UNITED STATES PATENT AND TRADEMARK OFFICE  
**CERTIFICATE OF CORRECTION**

PATENT NO. : 7,349,226 B2  
APPLICATION NO. : 10/638982  
DATED : March 25, 2008  
INVENTOR(S) : Ice

It is certified that error appears in the above-identified patent and that said Letters Patent is hereby corrected as shown below:

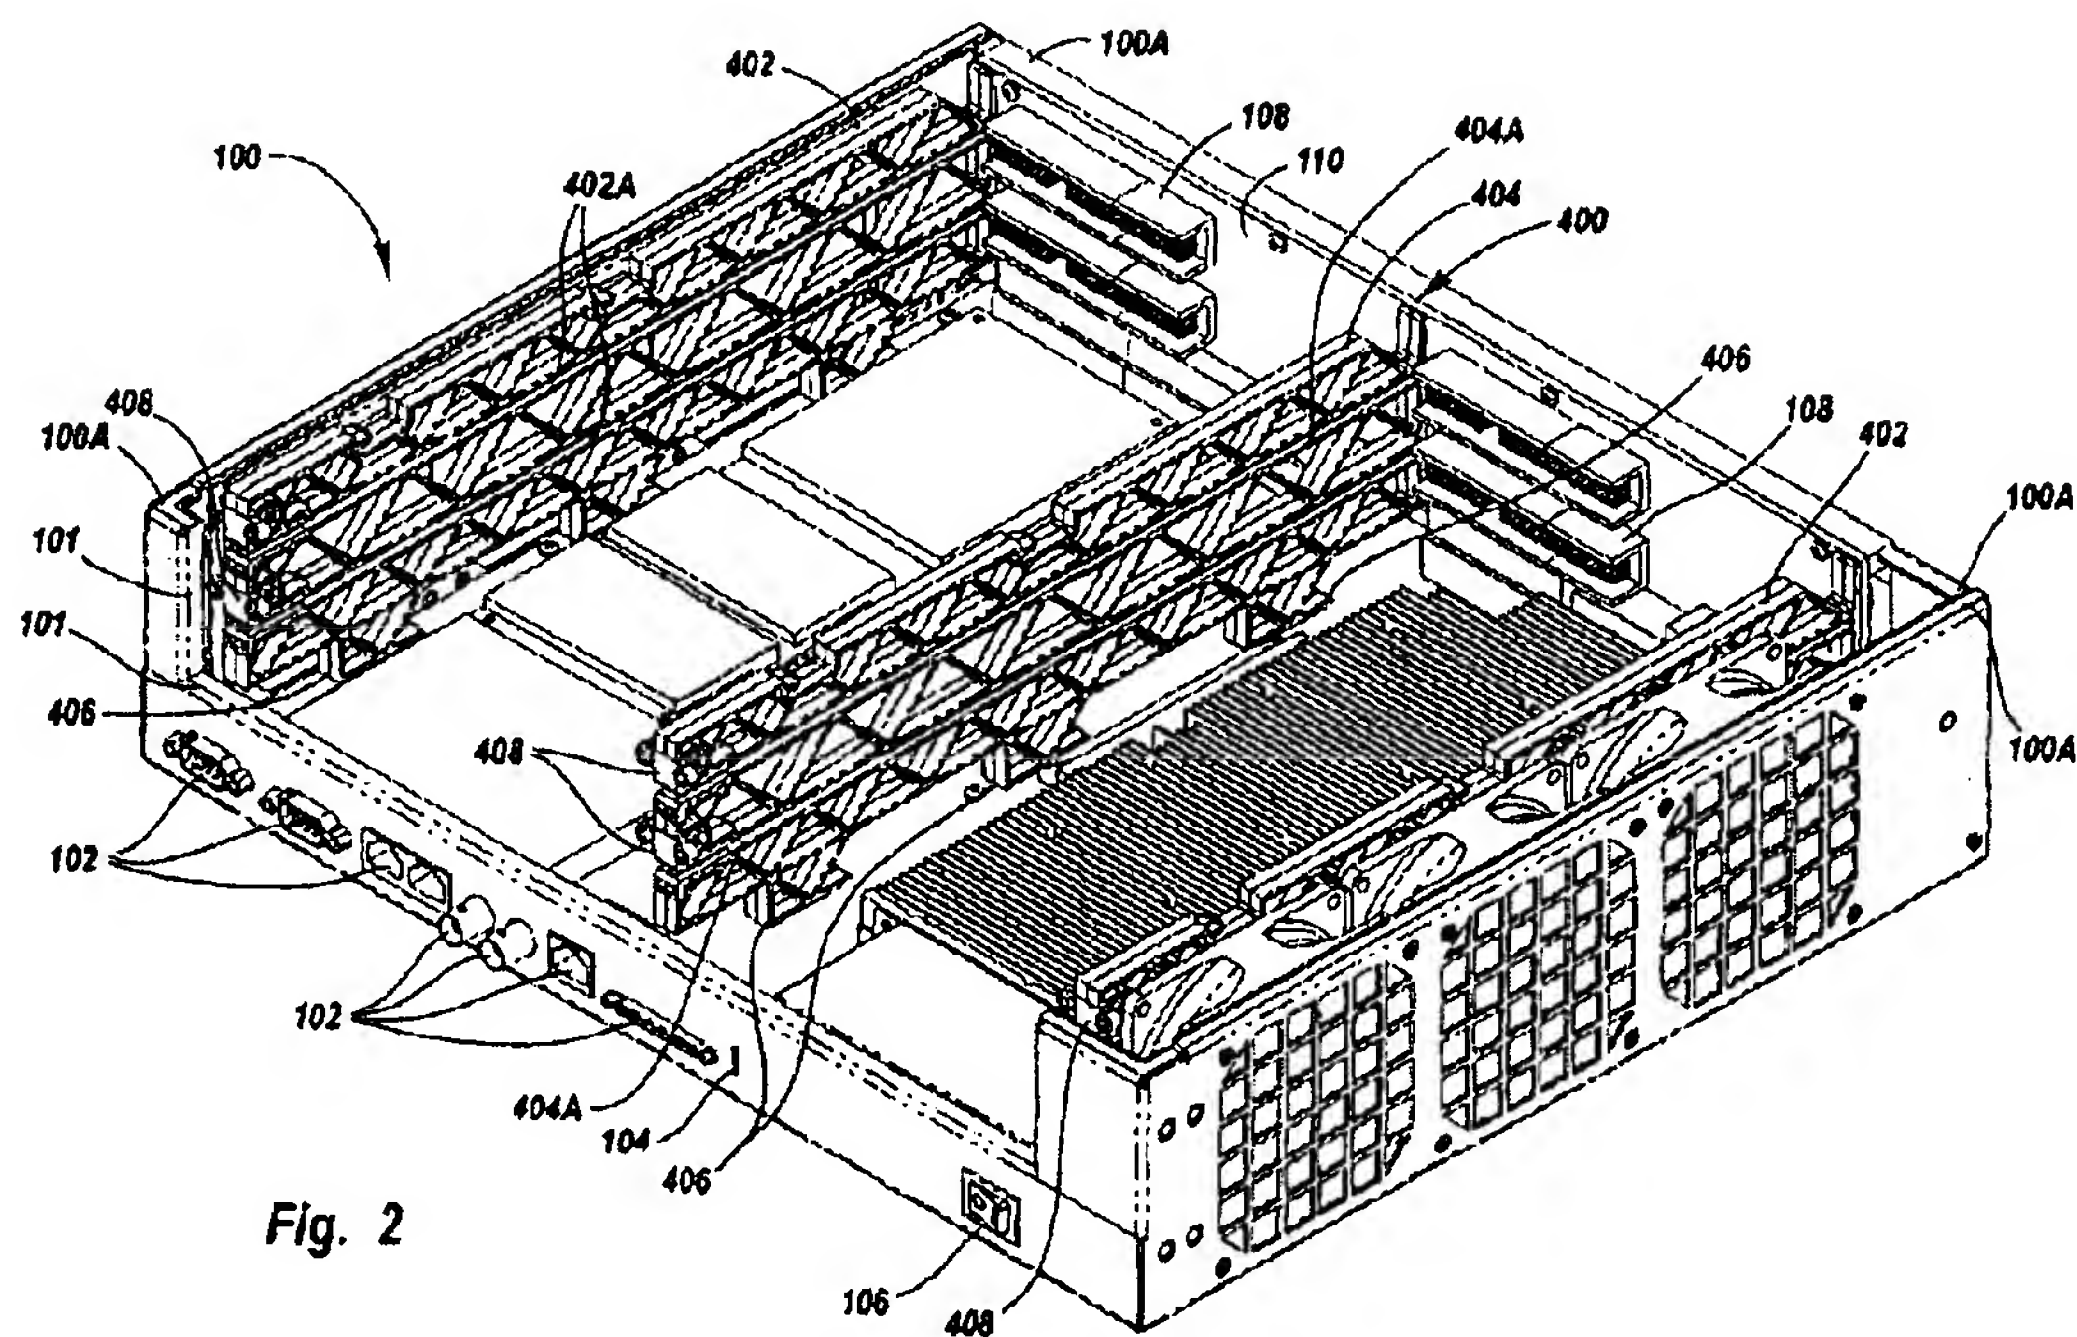
Sheet 1, replace Figure 1 with the figure depicted below, wherein the connectors 306 have been relabeled 312

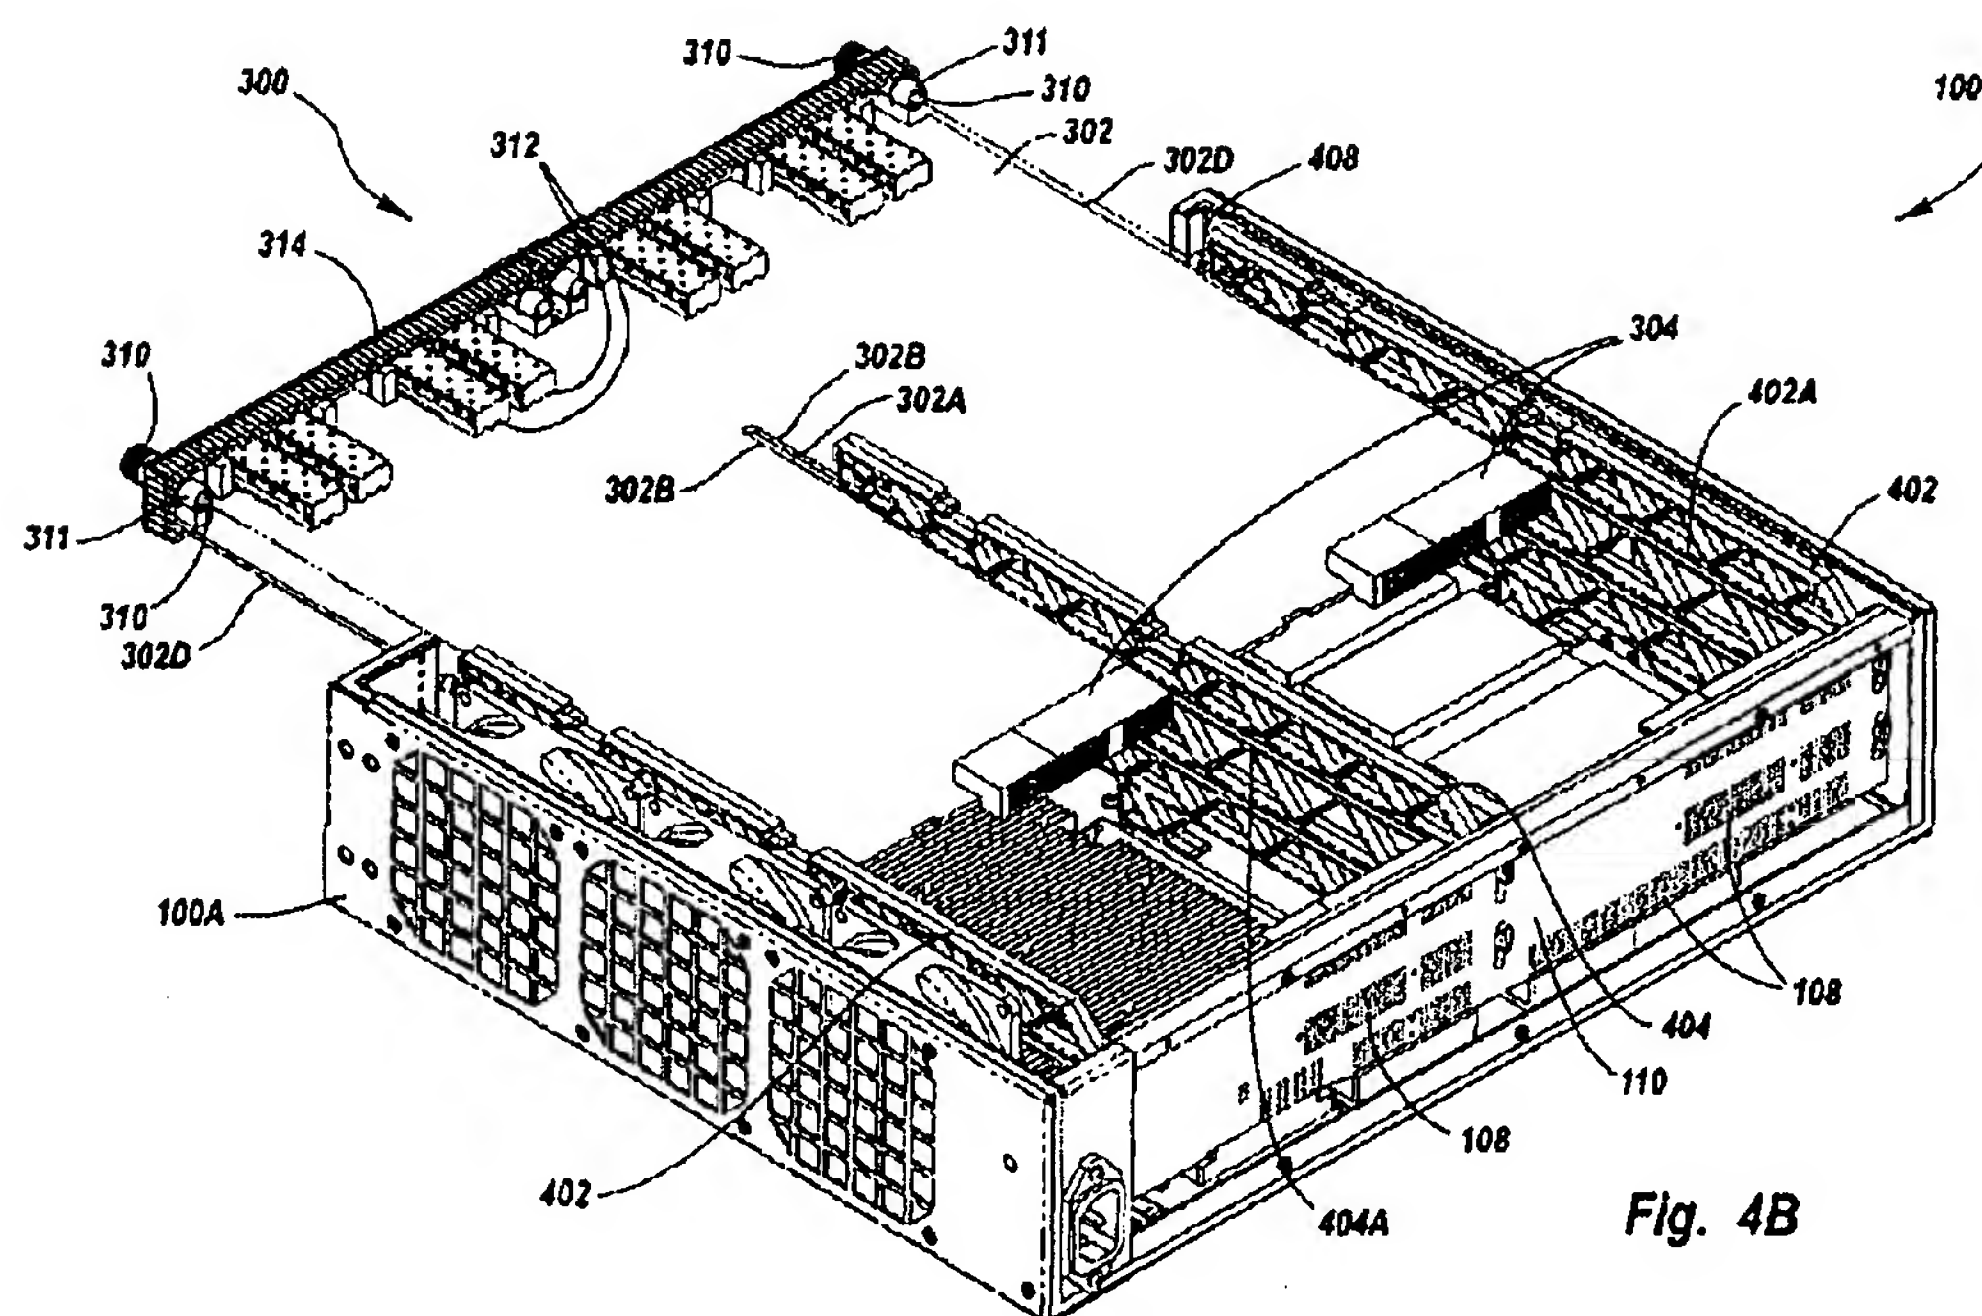
Sheet 2, replace Figure 2 with the figure depicted below, wherein the channel 404G has been relabeled 404A
